# UNITED STATES PATENT AND TRADEMARK OFFICE

APPLICATION NO.	FILING DATE	FIRST NAMED INVENTOR	ATTORNEY DOCKET NO.	CONFIRMATION NO.
10/691,854	10/23/2003	Mark H. Falahee	FLH-10702/29	6727

## Office Action Summary

REPLACEMENT DRAWING SHEET

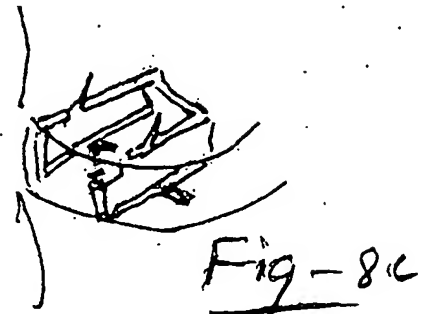
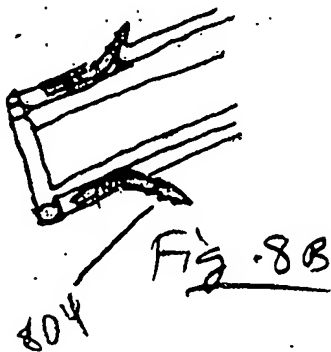
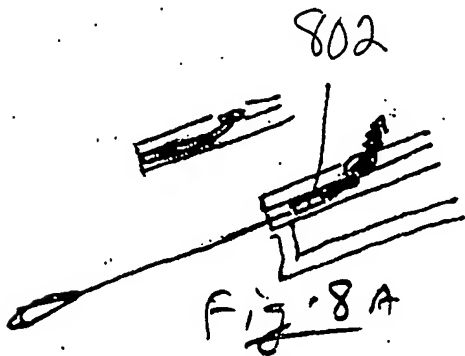
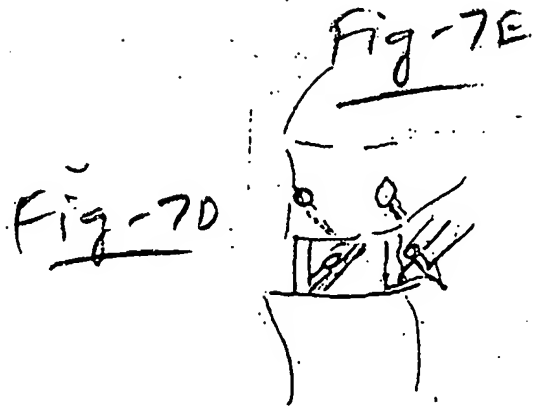
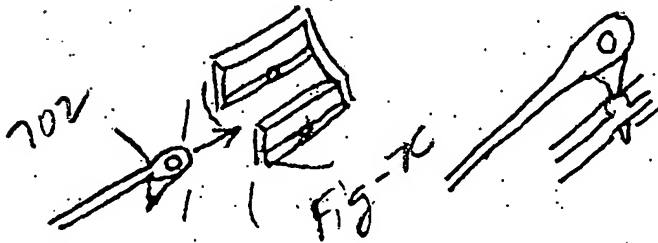
Not  
Approved  
For  
Entry  
PBP  
8-16-05

**Fig - 7A**

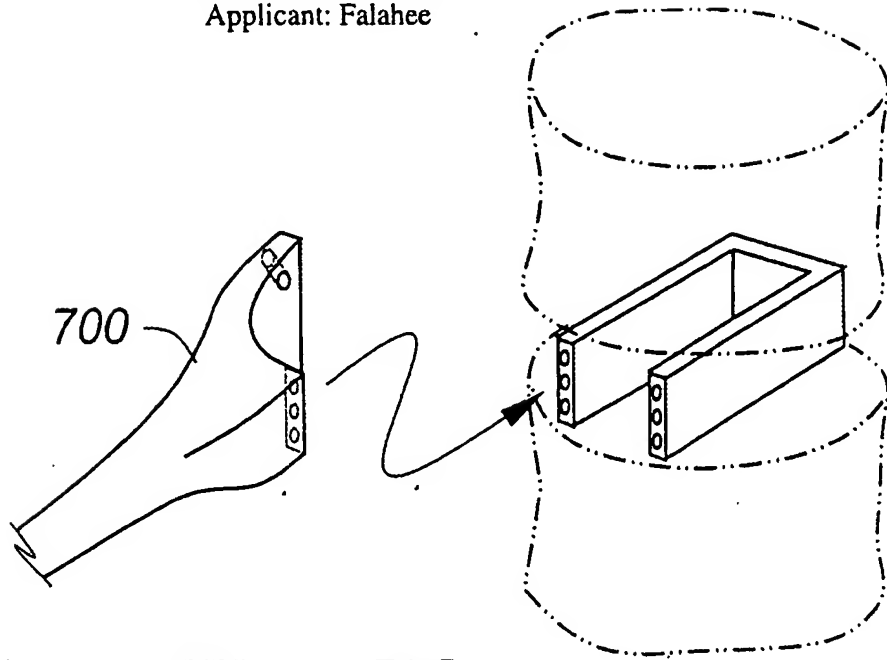
Proposed drawing changes were received on June 13, 2005. The proposed changes were not approved because Figures 7A and 7B attempt to add new matter to the specification. In particular, the detailed features of shape and details of the figures do not appear to have original support from the specification or original drawings. The drawing changes proposed for Figures 9A and 9B are acceptable and would be entered if filed in a separately filed set of proposed drawing changes.

Not  
Approved  
For  
Entry  
BP  
8-16-05

New corrected drawings in compliance with 37 CFR 1.121(d) are required in this application because the ones filed June 13, 2005 are not acceptable. Applicant is advised to employ the services of a competent patent draftsman outside the Office, as the U.S. Patent and Trademark Office no longer prepares new drawings. The corrected drawings are required in reply to the Office action to avoid abandonment of the application. The requirement for corrected drawings will not be held in abeyance.
